# Wollongong Local Planning Panel Assessment Report | 1 September 2020

<b>WLPP No.</b>	Item 2
<b>DA No.</b>	RD-2019/1429/A
<b>Proposal</b>	Subdivision - Torrens title - two (2) residential lots and tree removal
<b>Property</b>	6 Gum Tree Lane Thirroul
<b>Applicant</b>	Mr Jason Ward
<b>Responsible Team</b>	Development Assessment and Certification – City Wide Team (KR)

## ASSESSMENT REPORT AND RECOMMENDATION

**Figure 1:** Excerpt from proposed Subdivision Plan submitted in original DA-2019/1429 (also relevant to the Review of Determination application (RD-2019/1429/A))

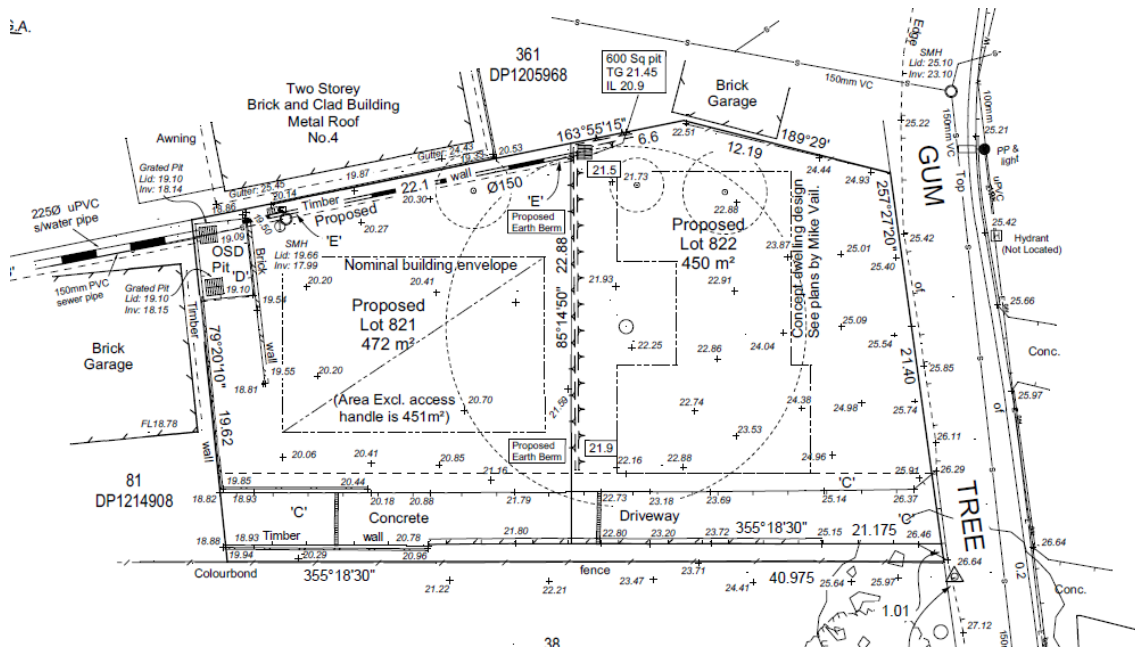
The Subdivision Plan submitted in the original DA-2019/1429 demonstrates a building envelope for each proposed lot however the building envelope for proposed Lot 822 is irregular shaped and both building envelopes encroach significantly within the tree protection zone of Tree 1.

The application under Review is seeking to remove Tree 1 which may enable a regular shaped compliant building envelope to be provided for each lot, clear of site constraints. An amended Subdivision Plan was not submitted as part of the application under Review to demonstrate compliance with this Clause.

The original application DA-2019/1429 also sought to remove a further three (3) trees along the eastern boundary due to conflicts with stormwater drainage – see Figure 1. This included an Illawarra Flame tree, Macadamia and Bottle-brush identified as Tree 2, 3 and 4 in the Arborist Report submitted for DA-2019/1429 (prepared by Moore Trees dated December 2019). Council's Landscape Officer did not support removal of the Illawarra Flame tree however had no objection to removal of Tree 3 and 4, (Macadamia and Bottle-brush).

**Figure 4:** Excerpt from Tree Protection Plan DA-2019/1429

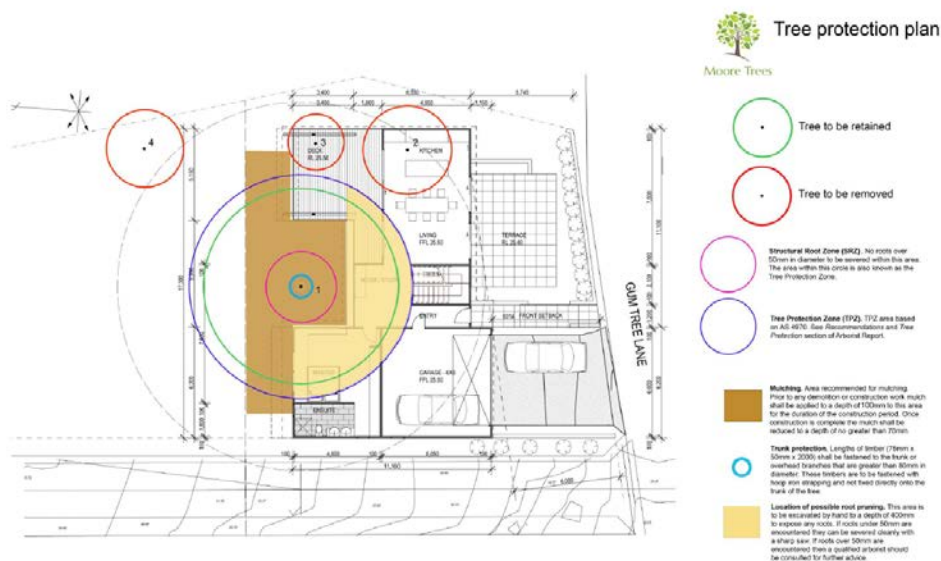
The original DA-2019/1429 for a two lot Torrens title subdivision of Lot 82 was refused on 26 March 2020. An excerpt from the Subdivision Plan is provided at Figure 1. The Tree Protection Plan is provided at Figure 4 below showing proposed retention of Tree 1 and removal of three (3) trees along the eastern boundary.
